### REMARKS

**In the Drawings:**

FIG. 14

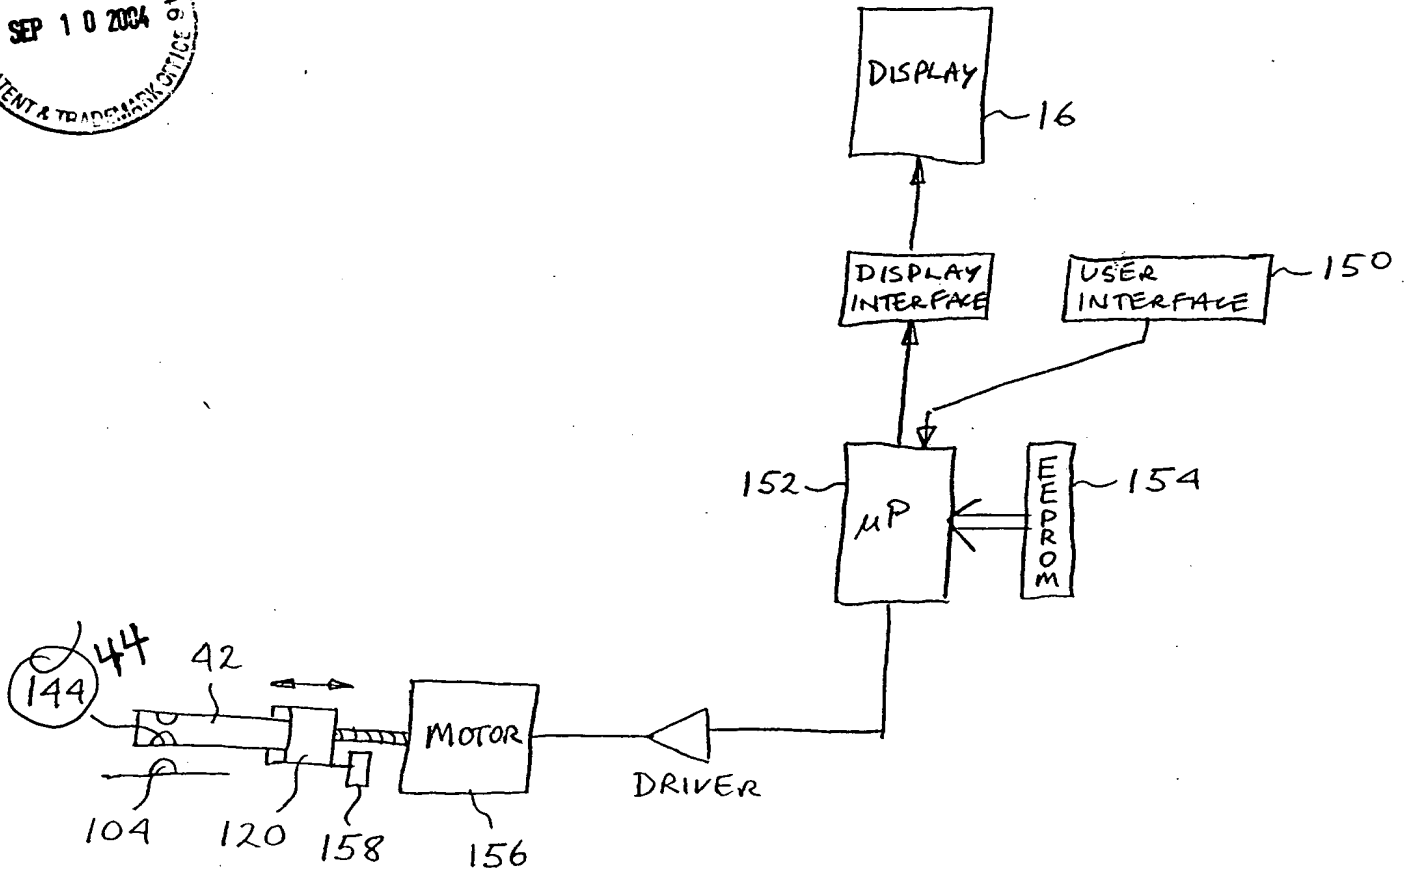
The drawing of Figure 14 has been amended to correct an obvious oversight as to the appearance of a reference number 144 in original Figure 14, instead of a reference number 44, as reflected in the new drawing of Figure 14. As amended, the drawing of Figure 14 is consistent with the specification, for example, paragraph [0077] of the specification, and the drawings of Figures 2 and 9A. No new matter has been added by virtue of this amendment.
